RE: **ADDENDUM NO. 1**

RE: ADDENDUM #1

Changes to Issue for Bid Documents Dated February 19th, 2026

PROJECT: RPS Project 2602 Carlson Elementary School Additions & Renovations

ENLARGED PLANS

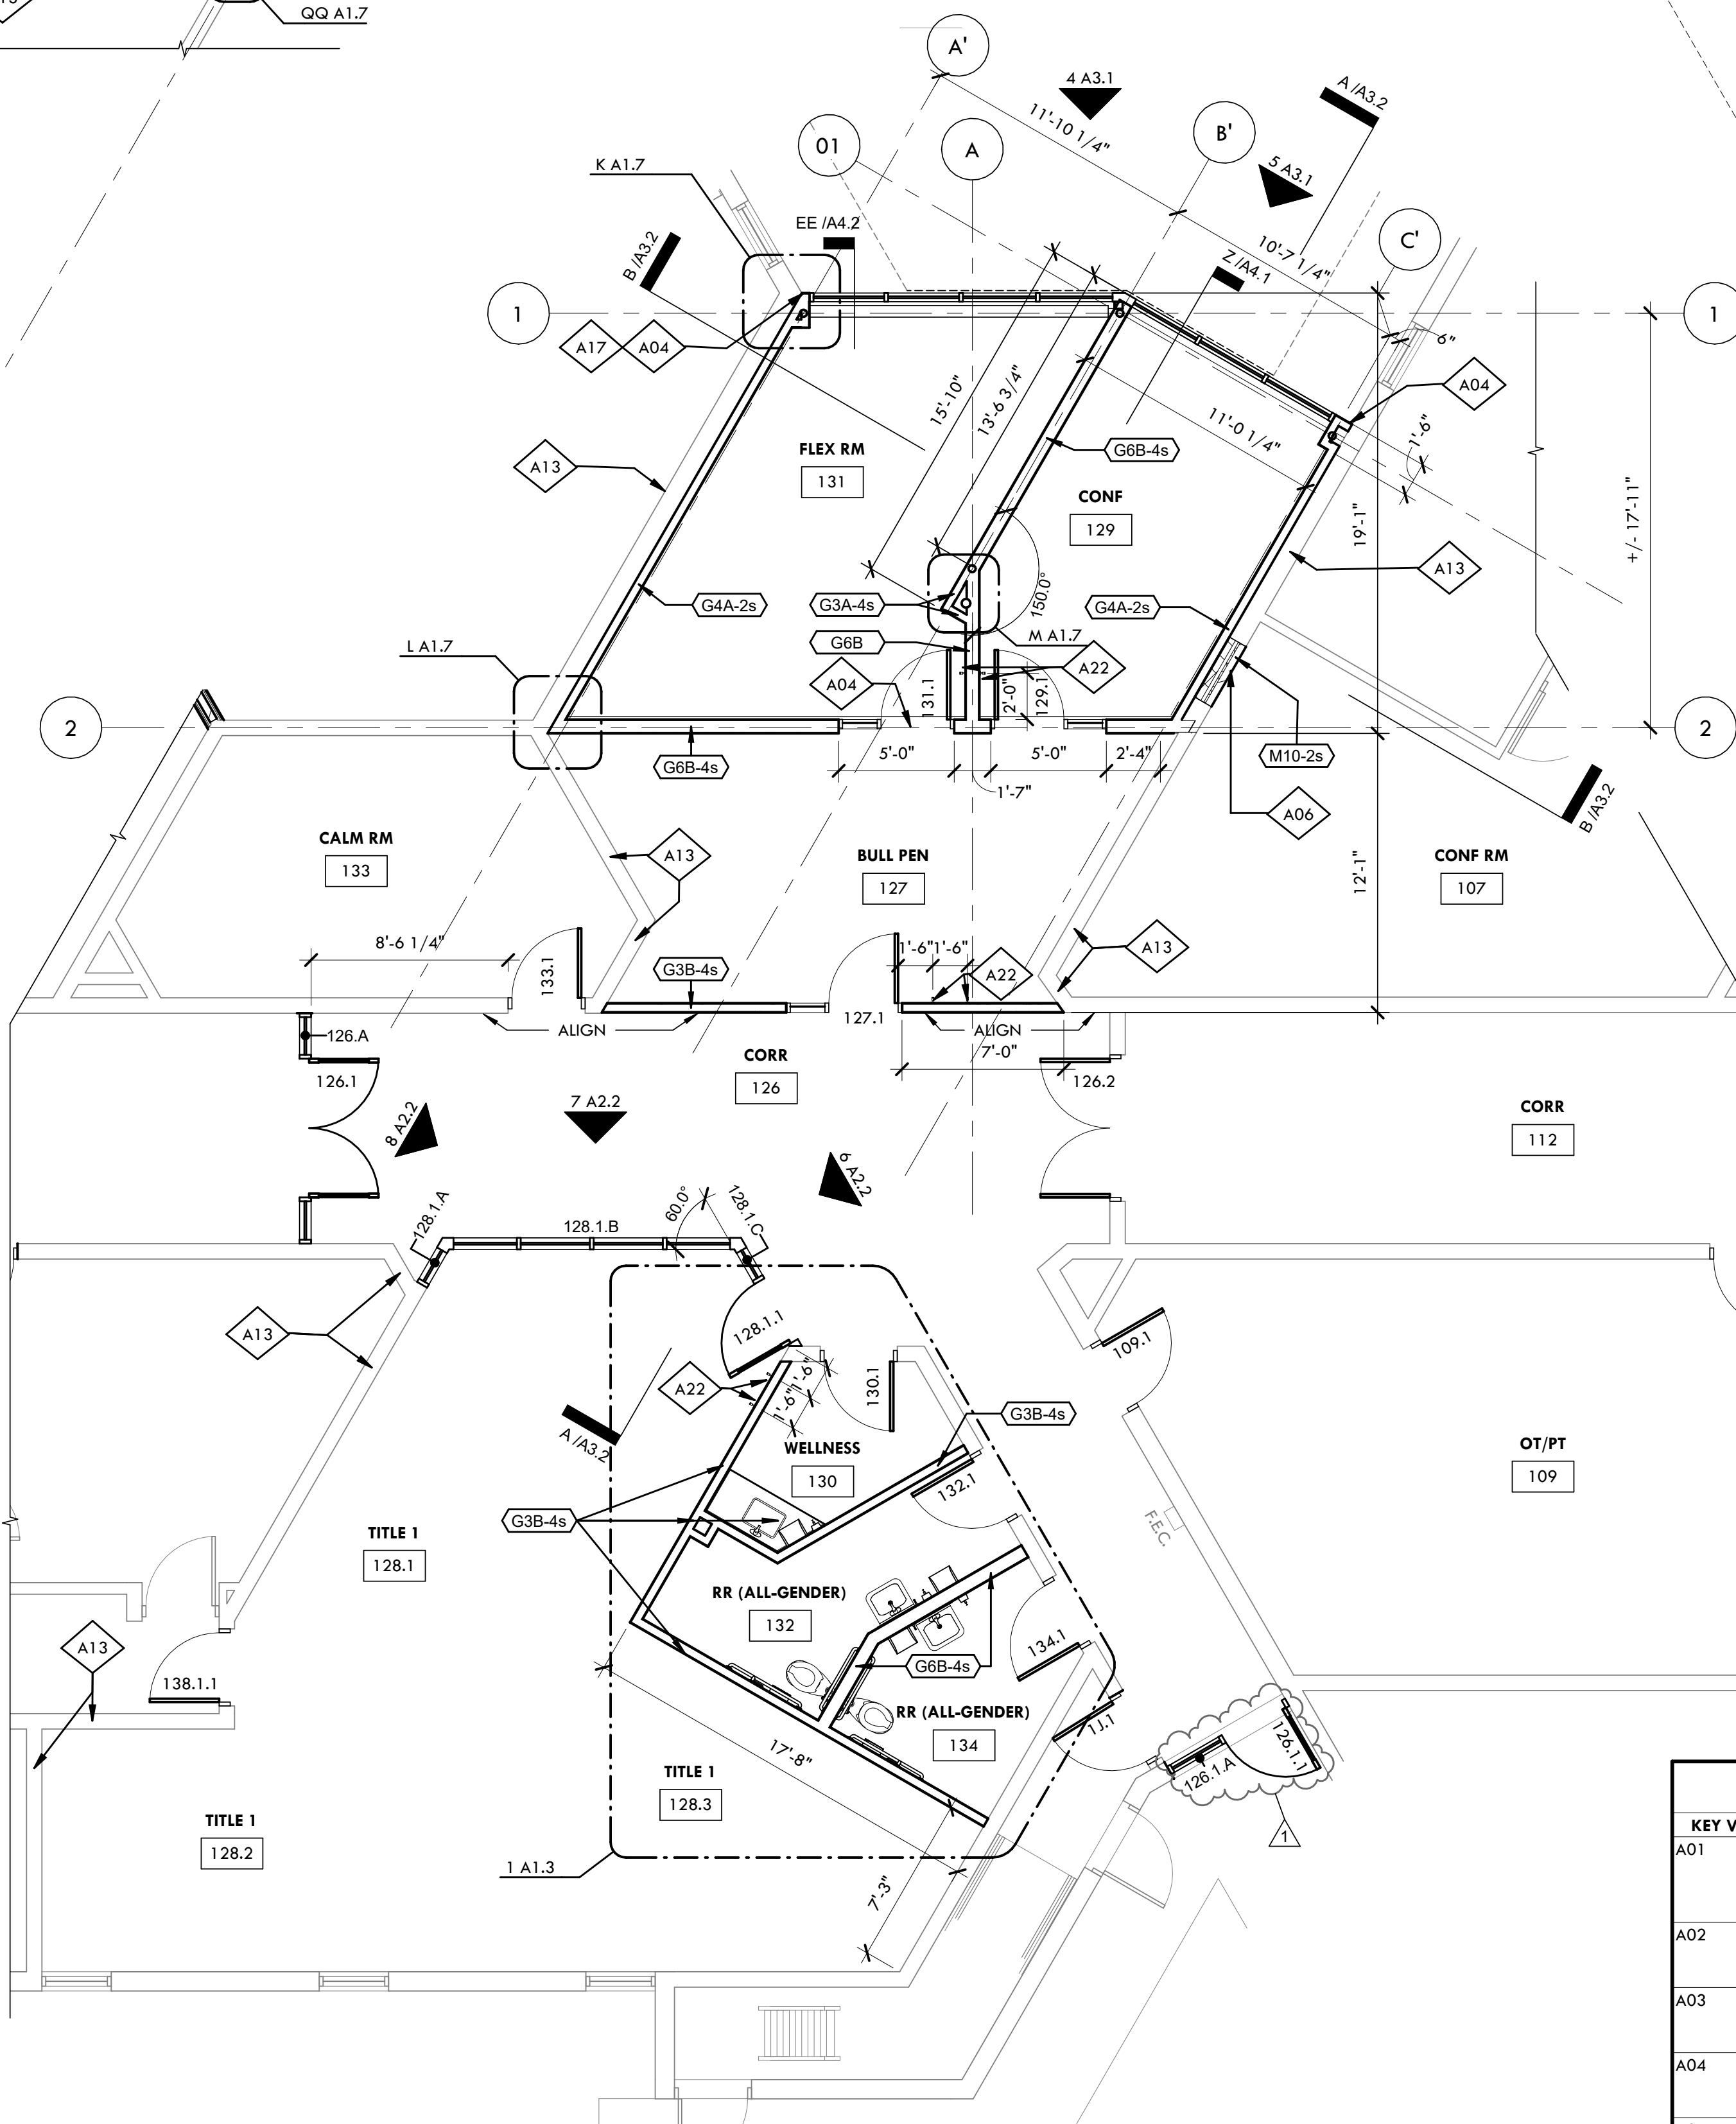
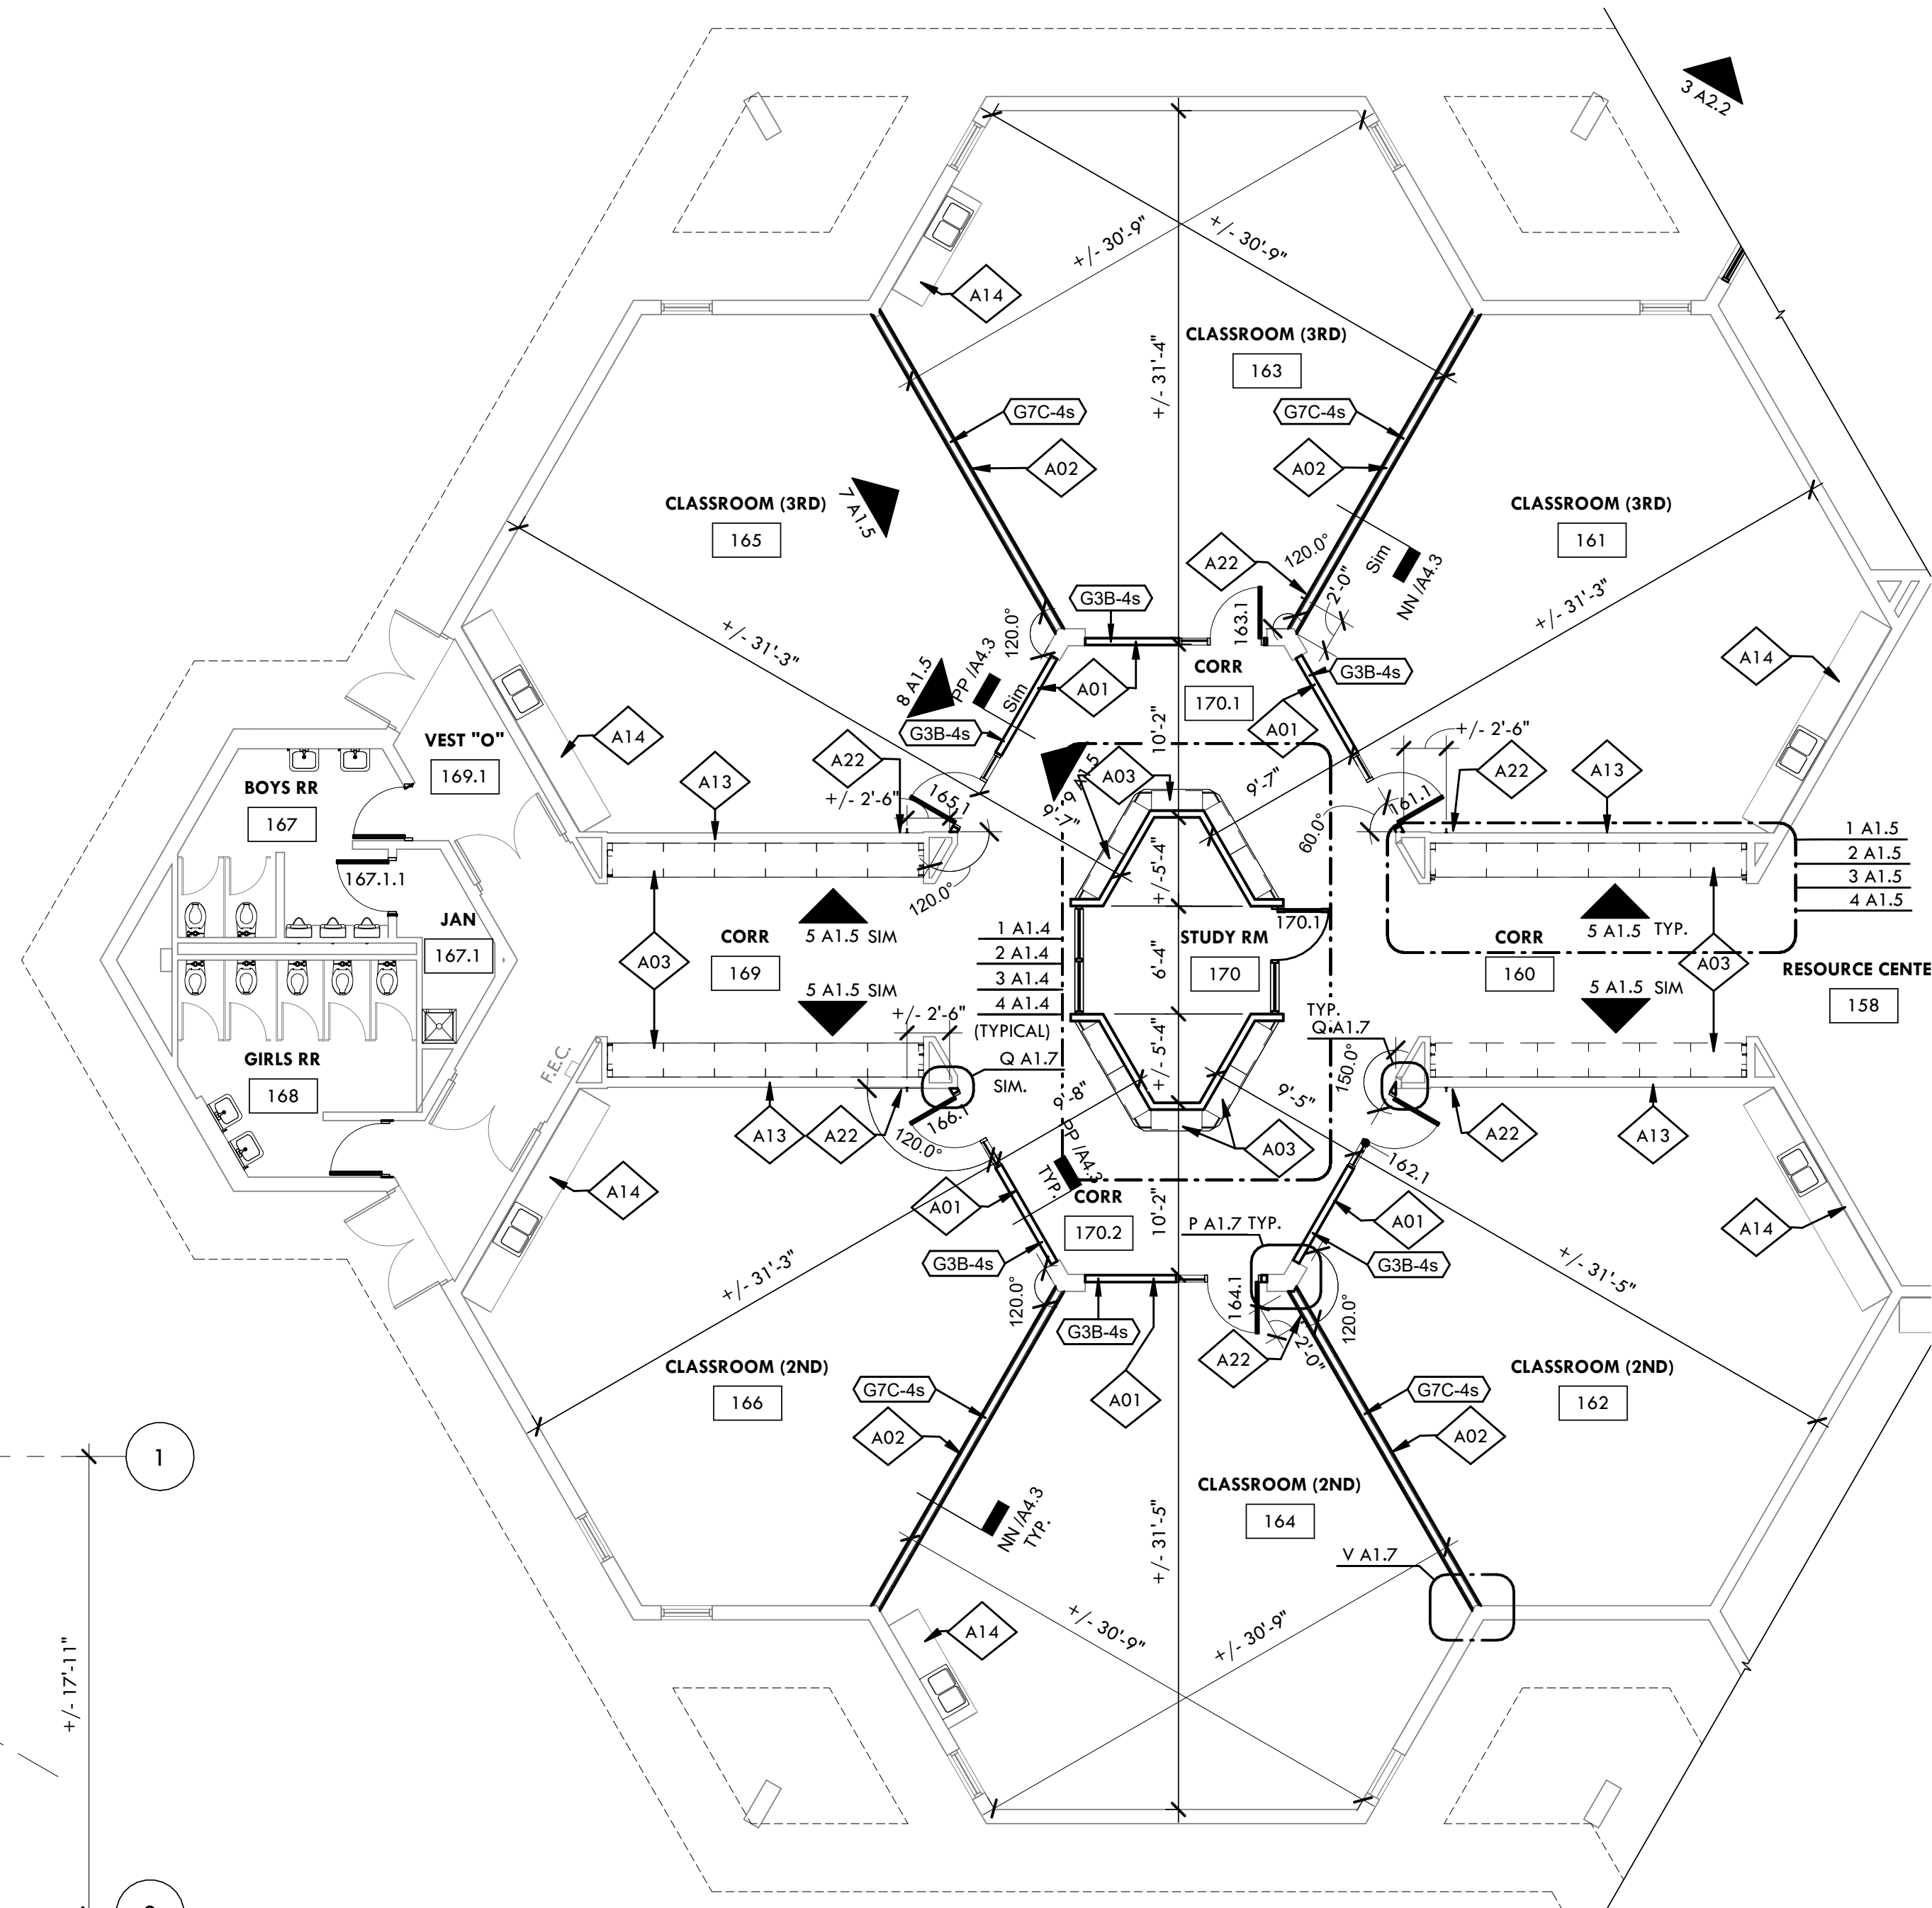
- A. Exterior door 126.1.1 and storefront 126.A have been added to the project.
